ATTACHMENT	1
ZON07-00016	
DRB	2/4/08

Re: Park Place Private Amendment Request  
File No. ZON07-00016

ATTACHMENT <u>2</u>
ZON07-00016
DRB 2/4/08

**Figure C-4: Downtown Master Plan**

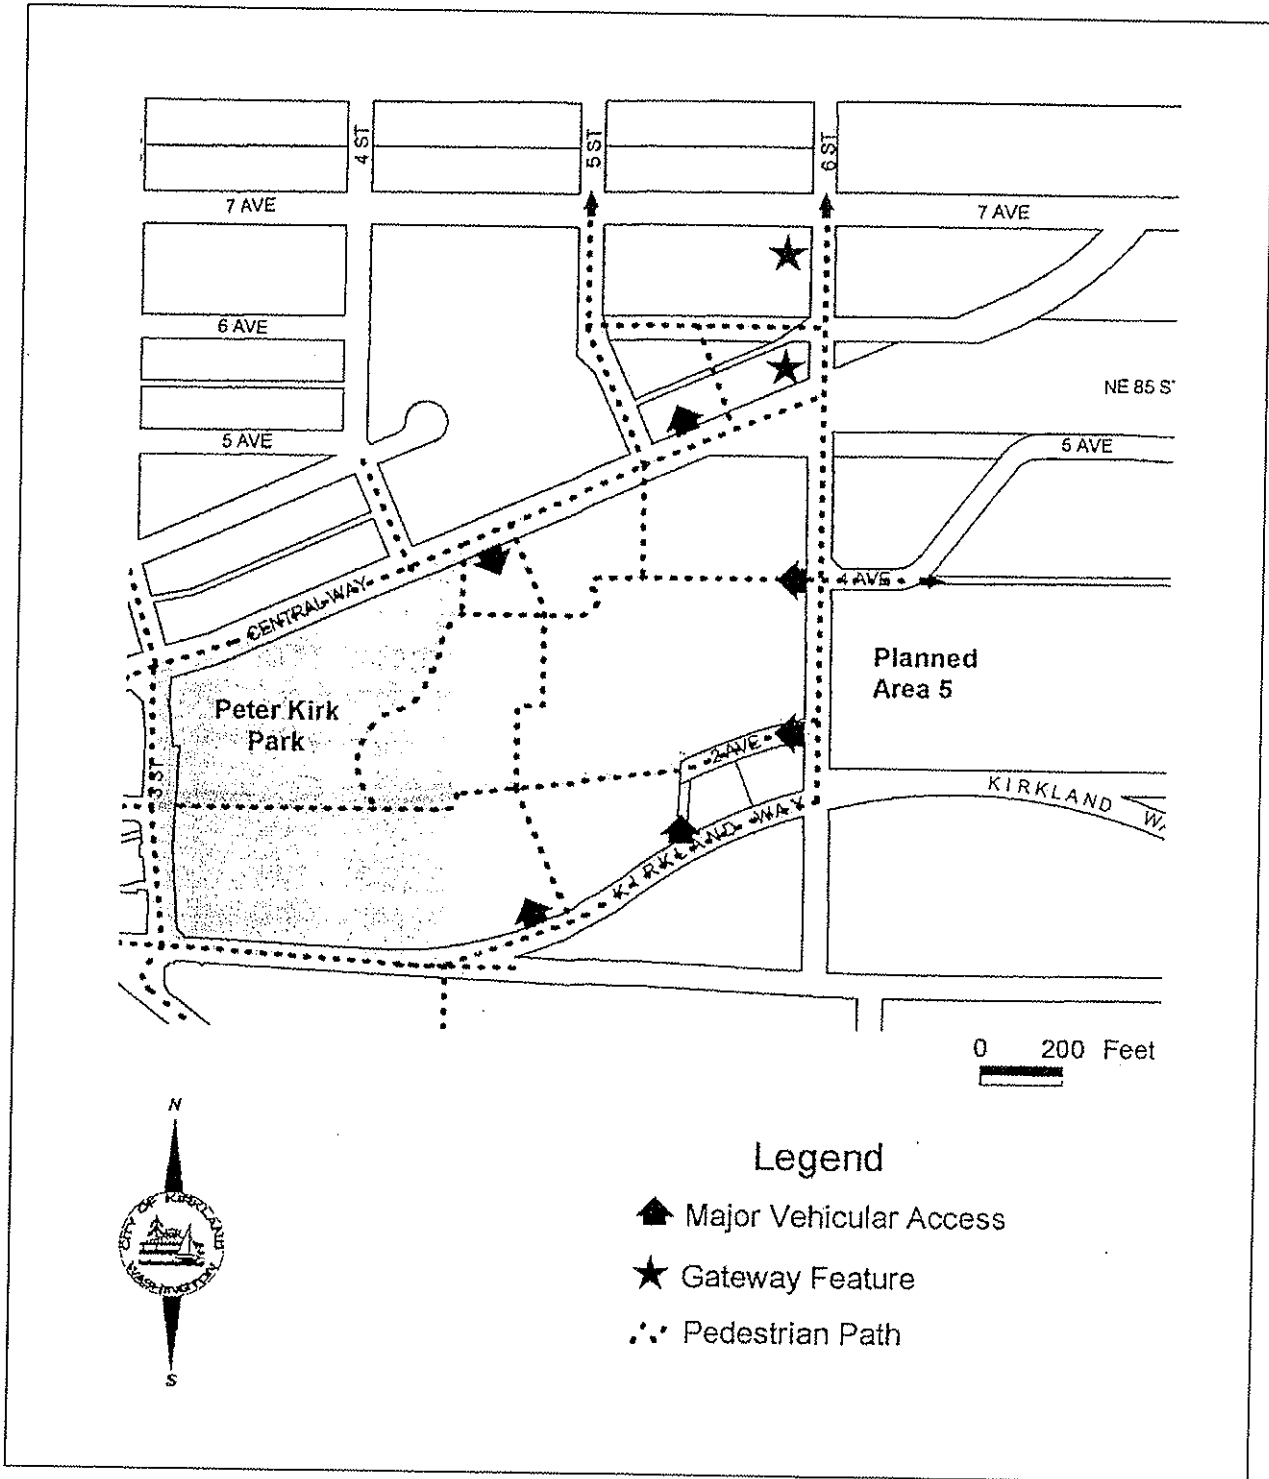
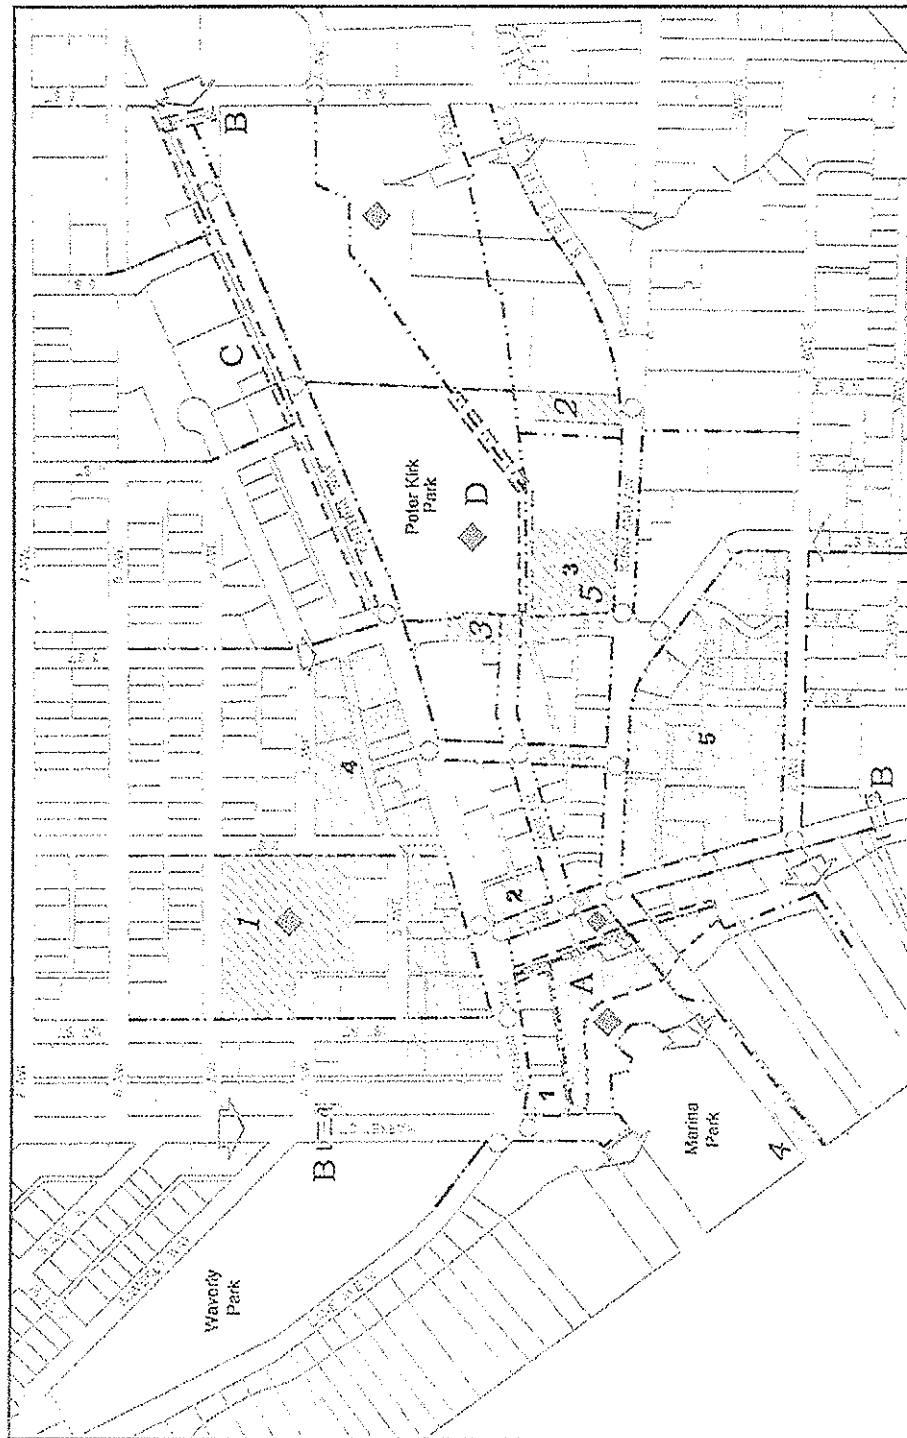
*The establishment and improvement of pedestrian pathways between activity centers should be a high priority policy objective. Major pedestrian routes within the Downtown area are identified in Figure C-4. Major pathways include the extensive east-west “spine” or “Park Walk Promenade,” which links the lake with points east of 6<sup>th</sup> Street and the shoreline access trail.*

As the attached maps from the Comprehensive Plan show, two major pedestrian pathways are planned through Design District 5, which will allow pedestrians from within the District and east of the District access to the “Park Walk Promenade” and the rest of the Downtown. One of these pathways was constructed as a requirement of development of other properties in CBD-5, which includes sidewalks on 2<sup>nd</sup> Avenue and on public easements through the Continental Plaza and Emerald Building properties. The redevelopment proposal would run that pedestrian pathway into the back of an 8-story building and then along a service road. Indeed, the pedestrian experience in the proposal would simply be street-side sidewalks next to tall buildings and pathways in the 25 to 50 foot gaps between 8-story buildings. Such is not the European quality pedestrian experience contemplated in the current Comprehensive Plan.
